**DECISION OF THE QUEENSTOWN LAKES DISTRICT COUNCIL**

<b>Applicant:</b>	Ziva Holdings Limited
<b>RM reference:</b>	RM150383
<b>Application:</b>	Application under Section 88 of the Resource Management Act 1991 (RMA) to establish a 981m <sup>2</sup> Residential Building Platform (RBP) with a 1500m <sup>2</sup> curtilage area. The proposed RBP will be subject to design controls associated with colours, reflectance, and building height. A water supply is proposed to be sourced from an onsite bore, and domestic effluent is to be treated and disposed to ground. Earthworks are proposed to provide for a residential development on the RBP, site preparation, and servicing.
<b>Location:</b>	Coal Pit Road, Gibbston
<b>Legal Description:</b>	Section 36 Blk III Kawarau SD (being also held with), Section 39 Blk III Kawarau SD, and Section 7 – 8 Survey Office Plan 357548, and contained within Computer Freehold Registers OT15C/297 and OT15C/298. The site has an area of 17.2704 hectares.

<b>Zoning:</b>	Gibbston Character
<b>Activity Status:</b>	<b>Discretionary</b>
<b>Notification Decision:</b>	Publicly Notified
<b>Delegated Authority:</b>	Blair Devlin – Manager, Resource Consenting
<b>Final Decis

Client	Surveyed	Signed	Date	Job No.	Drawing No.
COAL PIT HOLDINGS LTD.	LR		30.05.14	11331	03_01
	Drawn	Signed	Date	Scale	
	ED		04.05.15	1:2500 @ A1 1:5000 @ A3	
	Designed	Signed	Date	Datum & Level	Rev.
				Mt Nic 2000 & MSL	<b>B</b>

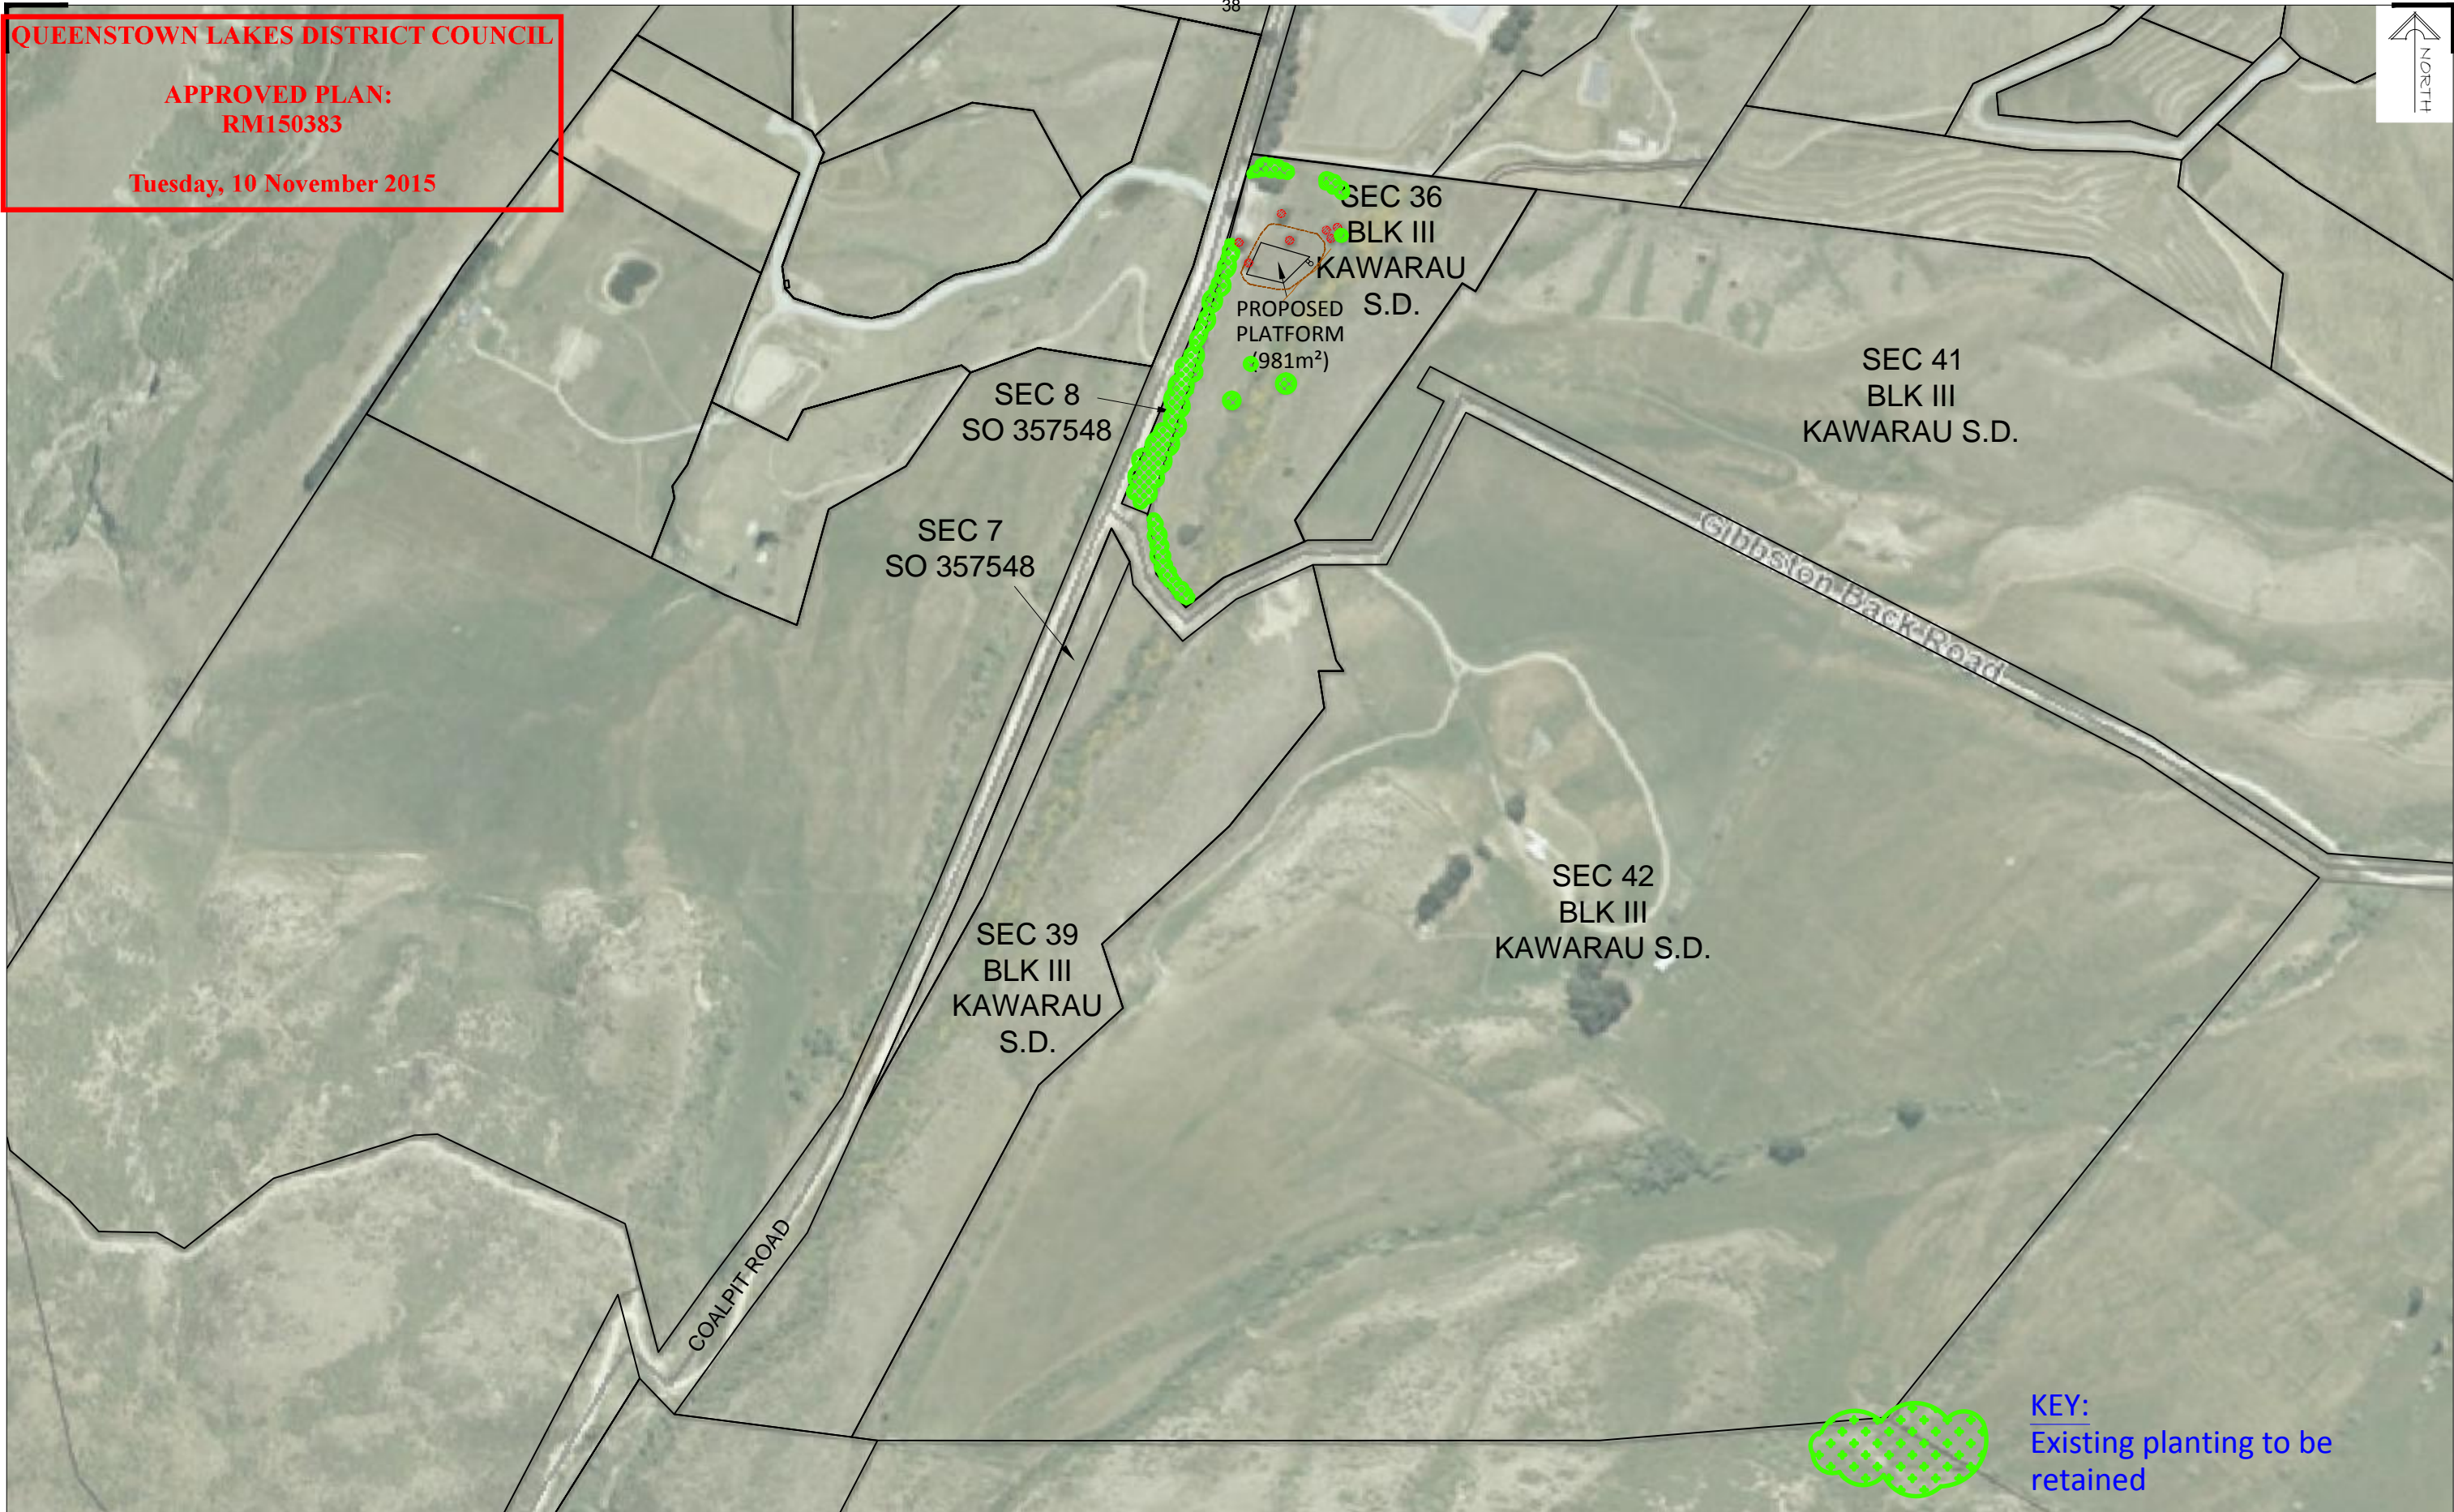
Mr Denney advises that he considers the bulk of the landscape planting identified on the submitted landscape plan would be inappropriate for this location. Proposed indigenous planting, existing pines near the northern boundary, and the *Ulmus glabra horizontalis* would however offer some mitigation in terms of visually buffering built form and the associated curtilage area and should be identified on an amended landscape mitigation plan.

14. The landscape plan submitted with the application however identifies a garden amenity type lineal planting alongside the roadside boundary. The planting includes ornamental hedging and various trees and shrubs that to a degree would increase the level of domestication of the site beyond that of the platform and curtilage area. I consider that parts of this planting would be out of character with the surrounding landscape. The planting also includes birch a problematic and invasive species that should be avoided within such close proximity to the ONL. The indigenous species within the mix would be of small ecological value and would be of a more appropriate character to the landscape setting. Overall I consider the proposed landscape planting would represent over domestication of the site and that the ornamental and problematic species should not be considered as mitigation towards the platform or protected via an approved landscape plan. I recommend that the plan is amended and resubmitted to council for certification to only identify the indigenous planting, pines to be retained near the northern boundary and the *Ulmus glabra horizontalis* to provide softening of future built form and domestication. Existing pines should be noted on the plan that if they are removed they are to be replaced with non-wilding evergreen species, as the existing pines are wilding species.

18. As discussed above I consider the bulk of the landscape planting identified on the submitted landscape plan would be inappropriate for this location. Proposed indigenous planting, existing pines near the northern boundary and the *Ulmus glabra horizontalis* would however offer some mitigation in terms of visually buffering built form and the associated curtilage area and should be identified on an amended landscape mitigation plan.

3. The submitted landscape plan shall be amended and resubmitted to council for certification within 6 months of granting consent. The amended plan shall achieve the following objectives:

- Identify only the indigenous species, *Ulmus glabra horizontalis* and existing monterey pines near the northern boundary of the property on the plan. The pines shall be identified that if removed they shall be replaced with non-wilding species of an evergreen tree, green in colour and of a mature height of no less than 6m.

Client	Surveyed	Signed	Date	Job No.	Drawing No.
COAL PIT HOLDINGS LTD.	LR		30.05.14	11331	03_02
	Drawn	Signed	Date	Scale	
	ED		4.05.15	1:500 @ A1 1:1000 @ A3	
	Designed	Signed	Date	Datum & Level	Rev.
				Mt Nic 2000 & MSL	B

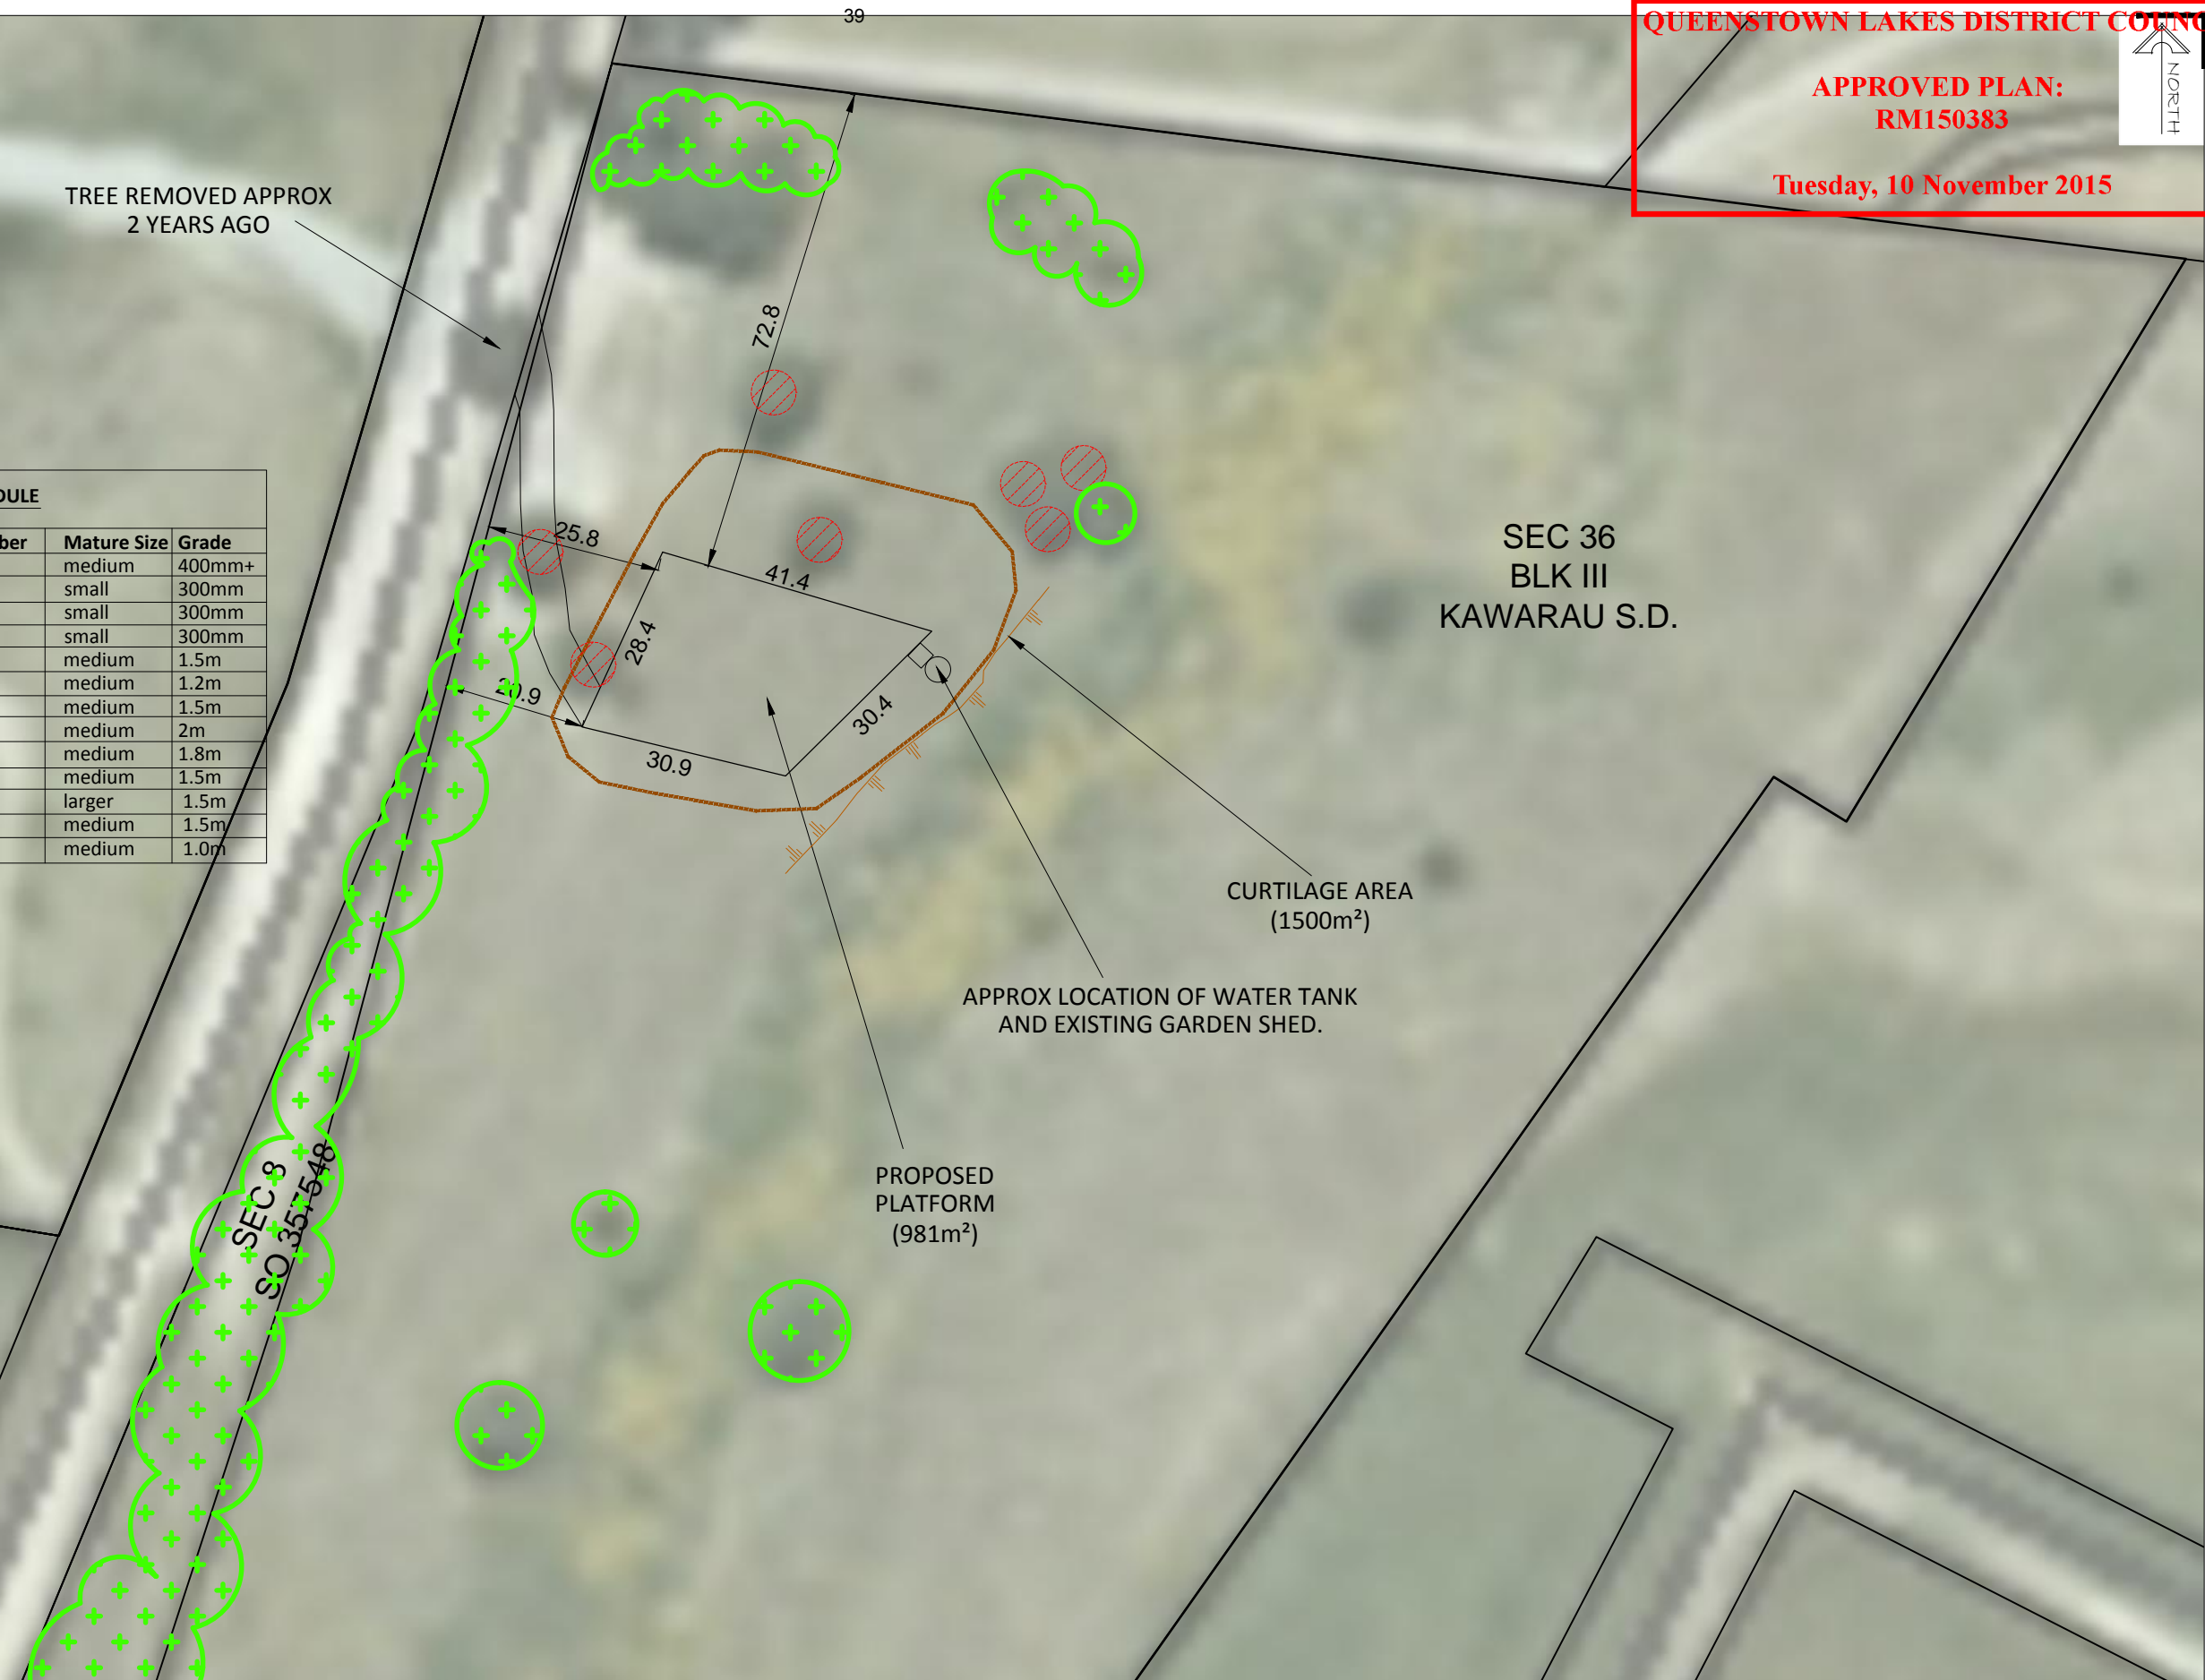
25. As discussed above proposed landscaping would not be consistent with traditional rural elements and would include birch a problematic weed species. As above I recommend that the submitted landscape plan be amended to avoid ornamental planting alongside the boundary and remove birch to ensure planting is in keeping with the rural Gibbston character.

35. Most of the proposed boundary planting (partly planted) is lineal planting of domestic ornamental species and includes areas of silver birch an invasive and problematic species. In terms of mitigation value of the development and maintaining the character of the Gibbston Valley the boundary planting is of very limited value. The submitted landscape plan should be amended to remove the birch and only identify those species of mitigation value to the development.

37. Should consent be granted I consider that the following conditions should be included:
  - i. The submitted landscape plan shall be amended and resubmitted to council for certification within 6 months of granting consent. The amended plan shall achieve the following objectives:

- Identify only the indigenous species, *Ulmus glabra horizontalis* and existing monterey pines near the northern boundary of the property on the plan. The pines shall be identified that if removed they shall be replaced with non-wilding species of an evergreen tree, green in colour and of a mature height of no less than 6m.
